Office Action Summary

10/576,744

DUKE, JAMES RICHARD JOHN

FIG. 2

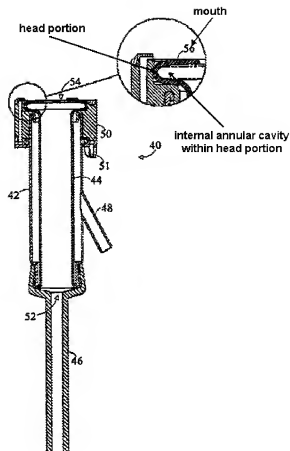
17. In re claims 39 and 42, Wipperfurth et al. shows milking equipment comprising: at least one milking cluster (Fig. 1) including a plurality of teat cups (13); each of said teat cups comprising a flexible liner (Fig. 2: 44) for engaging about a teat of an animal to be milked, said liner having a head portion at one end provided with a mouth (56) through which said teat is engageable with said flexible liner, an internal annular cavity (see diagrammed Fig. 2 below) and a milk discharge passageway (at bottom opening 52 of

the teat cup) at the opposite end thereof; post-milking flushing means (50) for discharging treatment fluid upon termination of a milking stage (Col. 6, lines 27-36); said post-milking flushing means comprising at least one nozzle (60, 62, 64); a plurality of short milk tubes (14) respectively connecting said discharge passageways of said teat cups to a clawpiece (10) which collects milk discharged from said teat cups for onward delivery; and control means (120, 170) for initiating supply of treatment fluid to said at least one nozzle of each of said teat cups upon take-off so that withdrawal of said teat cups wipes said treatment fluid down said teats (as discussed Col. 8, lines 57-61).

18. Wipperfurth et al. shows said post-milking flushing means comprising at least one nozzle (60, 62, 64) for discharging treatment fluid, but fails to show the post-milking flushing means is arranged to discharge treatment fluid in a direction towards said discharge passageway of the flexible liner. However, Guo teaches milking equipment (Fig. 6) comprising a teat cup (14) comprising a flushing means (30, 76) having at least one nozzle (26) arranged to discharge treatment fluid in a direction (as discussed in [0025] and indicated by arrows showing treatment fluid flow through means 30 and into
